Comments on Pre-public Draft Utulei NPDES Renewal Permit and Proposed Fact Sheet (AS0020001)

A. Comments on Proposed Fact Sheet

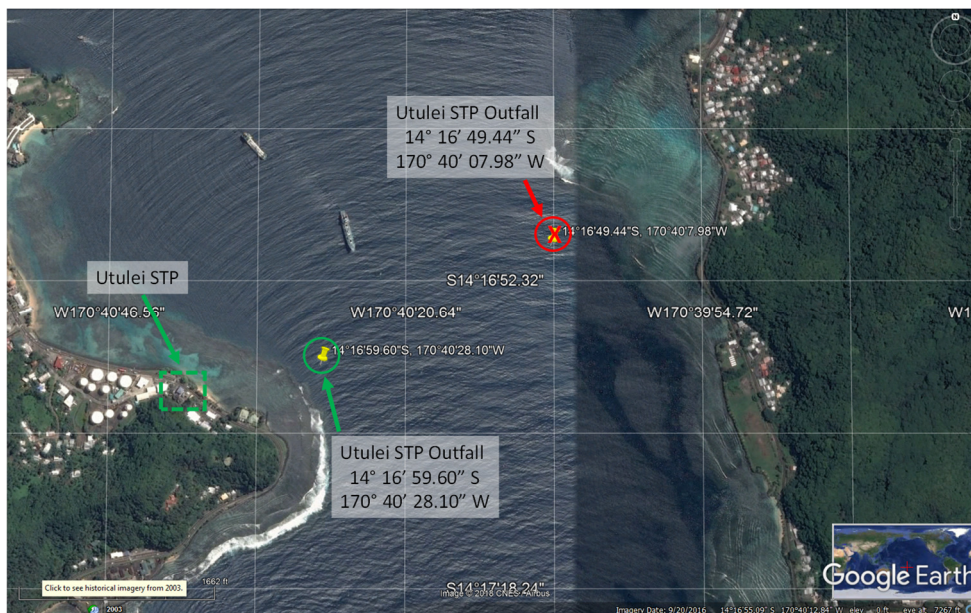
[1] The location of the discharge appears incorrect (perhaps it is based on an older coordinate system such as NAD27). Our best information based on recent data from fathometer and diver determined locations has the coordinates as shown in the Figure below: S 14° 16' 59.6"; W 170° 40' 28.1"
